**SITE PLAN REVIEW AND APPEARANCE BOARD
MEMORANDUM STAFF REPORT**

Project Name: Atlantic Crossing

The item before the Board is a Class II Site Plan Modification for **Atlantic Crossing**, pursuant to Land Development Regulations (LDR) Section 2.4.5(G)(1)(b):

SITE PLAN

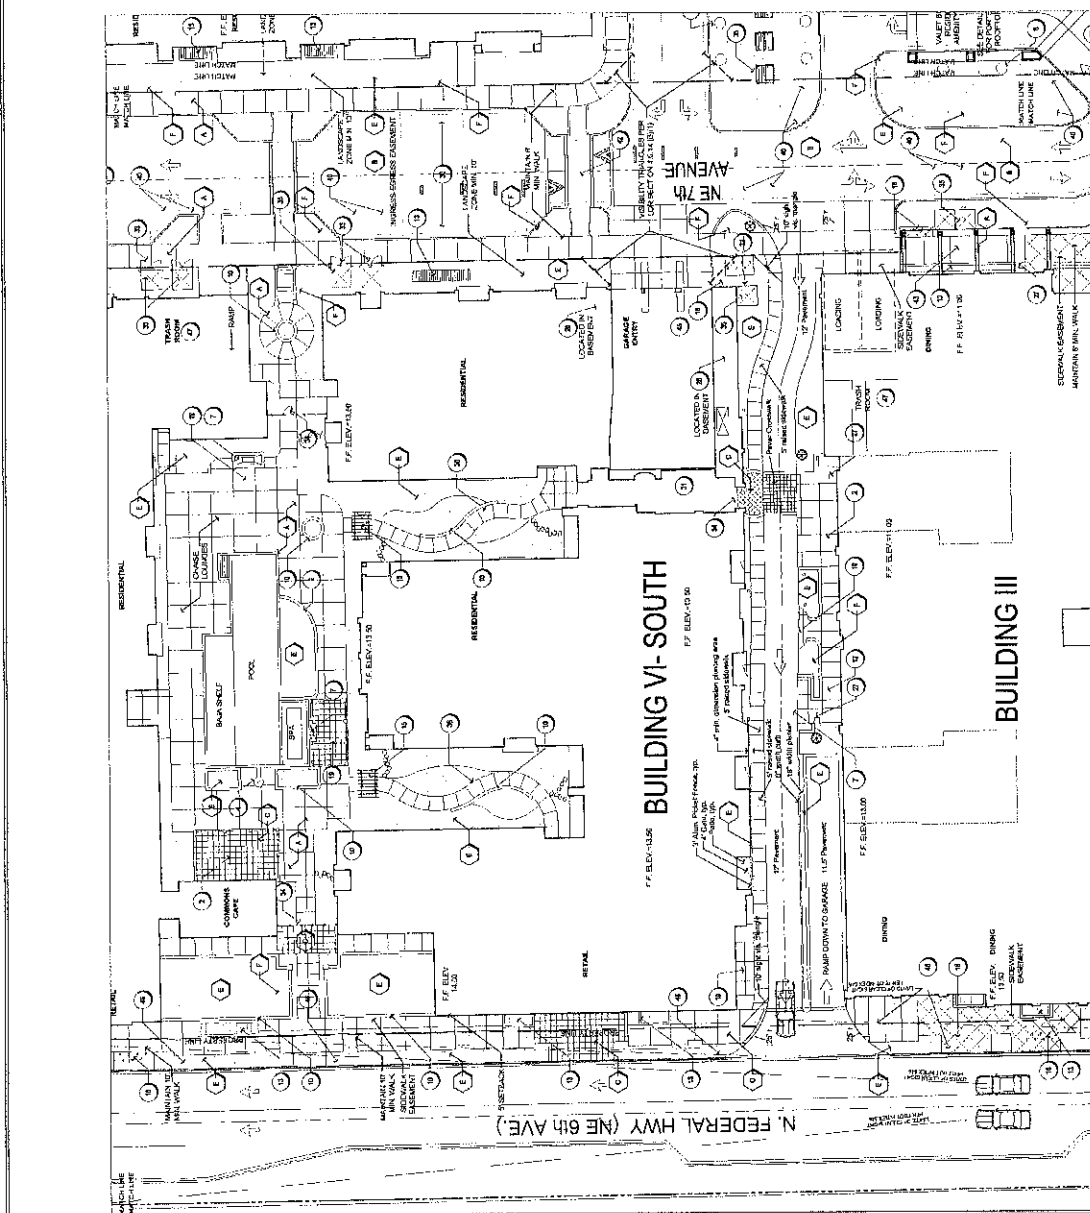
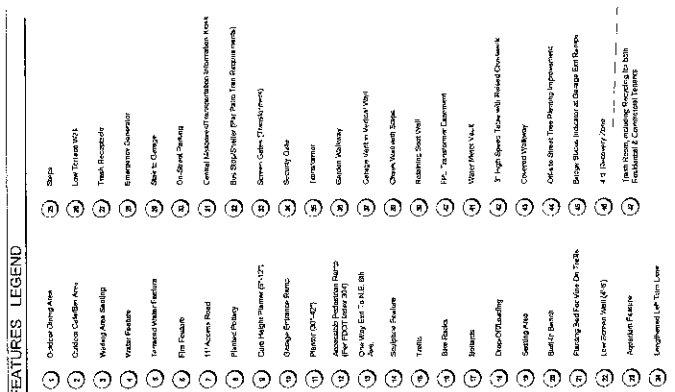
- Elimination of seating area, fire pit, landscaping, and meandering sidewalk.
- Construction of a 12-foot wide one-way westbound driveway that connects NE 7th Avenue to NE 6th Avenue that replaces the egress driveway from the subgrade parking area.
- Construction of a paver crosswalk mid-block between NE 7th Avenue and NE 6th Avenue.
- Construction of a 5-foot wide sidewalk along the north side of the driveway between NE 7th Avenue and NE 6th Avenue.
- Installation of associated landscaping.

3. In the event that it is determined that a surface driveway is necessary or desired, the report suggests that a portion of NE 7th Avenue become a one-way street essentially from the ingress to the egress of the valet queue located on the east side of NE 7th Avenue. The report also suggests that the mid-block cross walk on the north side of the valet queue exit be relocated or removed due to safety concerns since vehicles will be hitting it at an angle due to its proximity to the garage entrance and valet queue.

Per LDR Section 4.6.8, the maximum illumination for the driveway is 12 foot candles (2.9 foot candles proposed) and a minimum of 1 foot candles (1.0 foot candles proposed). The proposed driveway complies with the City's illumination levels.

The Senior Landscape Planner has reviewed the proposed landscape plan and found that it complies with LDR Section 4.6.16. The landscaping along the driveway consists of Dwarf Chenille Plant, Variegated Shell Ginger, Cat Palm, Croton, Japanese Privet, Petra Bromeliad, Bay Rum, Pringles Podocarpus, Bowstring Hemp, Confederate Jasmine, Thatch Palm, Mirror Leaf Viburnum, Sandankwa, Winin Palm, and Coontie.

Move denial of the Class II site plan modification for the **Atlantic Crossing**, by adopting the findings of fact and law contained in the staff report, and finding that the request is not consistent with the Comprehensive Plan and meets criteria set forth in Section 2.4.5(G) of the Land Development Regulations.

Move denial of the landscape plan for **Atlantic Crossing** based on a failure to make positive findings with respect to Section 4.6.16 of the Land Development Regulations.
